UCSF building seismic ratings
UCSF Rock Hall

CAAN #3001
1550 4th Street, San Francisco, CA 94158
UCSF Campus: Mission Bay

Rating summary	Entry	Notes
UC Seismic Performance Level (rating)	IV	Findings based on drawing review and ASCE 41-17 Tier 1 evaluation ¹
Rating basis	Tier 1	ASCE 41-17
Date of rating	2020	
Recommended UCSF priority category for retrofit	None	Priority A=Retrofit ASAP Priority B=Retrofit at next permit application for modification
Ballpark total project cost to retrofit to IV rating	N/A	See recommendations on further evaluation and retrofit
Is 2018-2019 rating required by UCOP?	Yes	Does not have a documented previous review
Further evaluation recommended?	No

BRB Connection from Sheet S-706 Using WF Section Welded to Top Flange of Transfer Girder at Line 15.

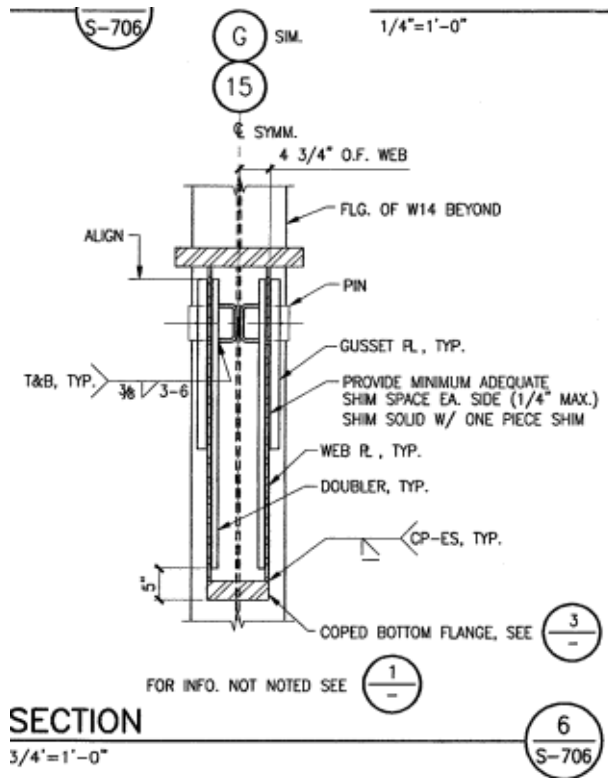
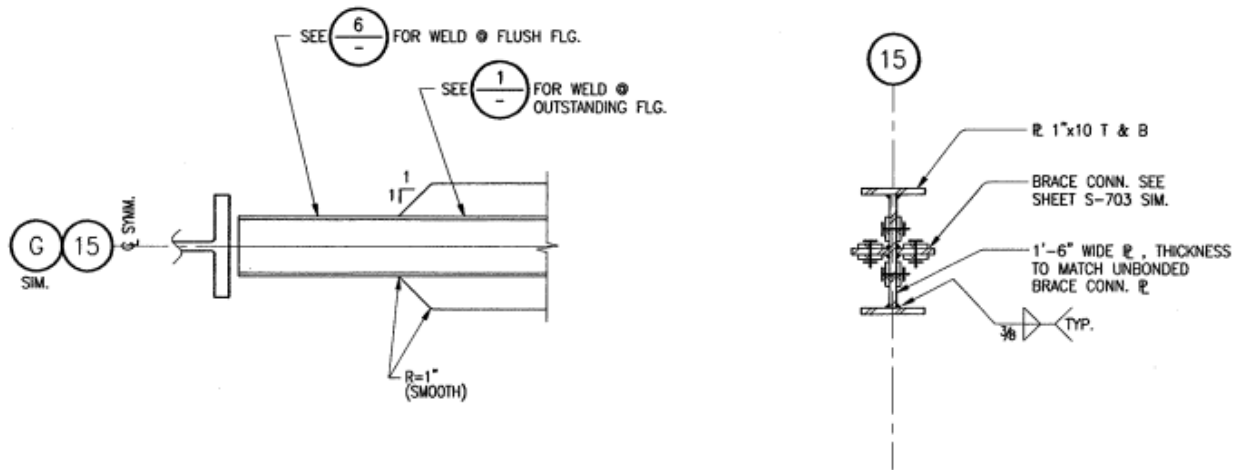
There is no Indication that the number of bolts differs from other locations with same BRB size (details are not drawn correctly but refer to schedule on Sheet S-703).

Enlarged Detail of Column Schedule: C19 (W14x109) and C27A (W14x120) both non-compact sections highlighted in red

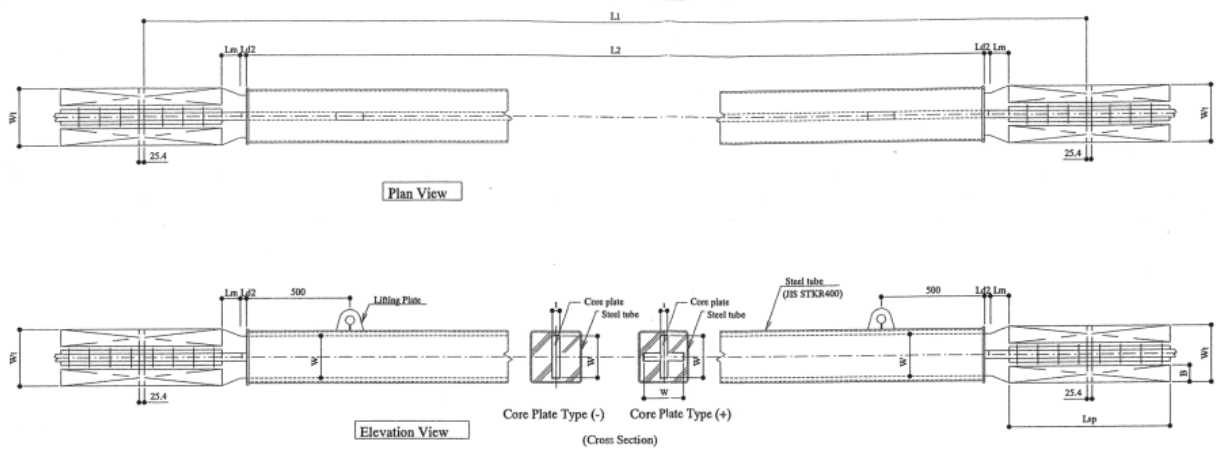
- Many columns do not meet the criteria for compact sections.
- There are some sizable diaphragm openings adjacent to the BRB braced bays. All lines of bracing have collectors shown on the plans, so it appears this issue was addressed in the original design.

Column Schedule Sheet S-702. All circled columns are in BRB frames.
Columns with red highlighting do not comply with compact section criteria in AISC 341-05.
Column F.3-12 (Type C19) and F.3-13 (Type C27A) in BRB frames were checked for ASCE 7-05 forces. See enlarged detail below.

Nippon Steel Shop Drawing Submittal Page 1 of 2 for UBB-1 to UBB-66 showing Configuration (+ or -), Size of Plates, No. of Bolts N1 and N2, Total No. of Bolts, Length Lsp of Bolt Group, etc. See enlarged detail below.

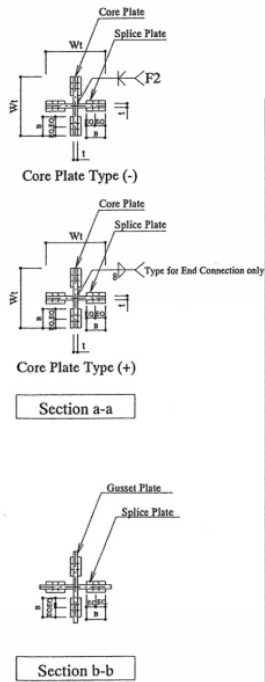
- There is an apparent disconnect between the number of bolts specified in the design and the number provided by Nippon for the connections along Line 15, Line B and a portion of Line C. It was not possible to visit the site to investigate, but the shop drawings by Nippon show half the required “total number of bolts” for connections on Line 15, Line B and part of Line C. This error was identified in the shop drawing review comments but should be verified to see that the appropriate number of bolts was provided.

<p style="text-align: center;">SHOULD BE DOUBLED? PLEASE VERIFY RV</p>				
Member Mark	Location and Quantity(pcs)					Joint Type	Bolt ² (ASTM A490: Out of Scope)			
	Line	Grid	Level	Type of UBB	Total		Dia (in)	N1 (pcs)	N2 (pcs)	Total ¹ (pcs)
UBB-67	15	C-E	1	X	1	A	1	5	5	40
UBB-68	15	G.3-H	1	Y	1	B	1	6	5	44
UBB-69	15	E-F.2	2	U	1	A	1	4	4	32
UBB-70	15	F.2-G.3	2	U	1	A	1	4	4	32
UBB-71	15	G.3-H	2	P	1	B	1	4	3	28
UBB-72	15	E-F.2	3	T	1	A	1	4	4	32
UBB-73	15	F.2-G.3	3	T	1	A	1	4	4	32
UBB-74	15	G.3-H	3	P	1	A	1	4	4	32
UBB-75	15	E-F.2	4	O	1	B	1	4	3	28
UBB-76	15	F.2-G.3	4	O	1	B	1	4	3	28
UBB-77	15	G.3-H	4	I	1	B	1	4	3	28
UBB-78	15	E-F.2	5	H	1	B	1	3	2	20
UBB-79	15	F.2-G.3	5	H	1	B	1	3	2	20
UBB-80	15	G.3-H	5	F	1	B	1	3	2	20
UBB-81	B	11-12	1	W	1	B	1	3	2	20
UBB-82	B	12-13	1	W	1	A	1	2	2	16
UBB-83	B	11-12	2	V	1	A	1	5	5	40
UBB-84	B	12-13	2	V	1	A	1	5	5	40
UBB-85	B	11-12	3	R	1	A	1	4	4	32
UBB-86	B	12-13	3	R	1	A	1	4	4	32
UBB-87	B	11-12	4	V	1	A	1	4	4	32

Enlarged Detail of Nippon Steel Shop Drawing Submittal Page 2 of 2 for UBB-67 to UBB-96. Shows clouded number of bolts at Gridlines, 15, B and C and Reviewer comment that total number of bolts should be doubled. This should be verified.
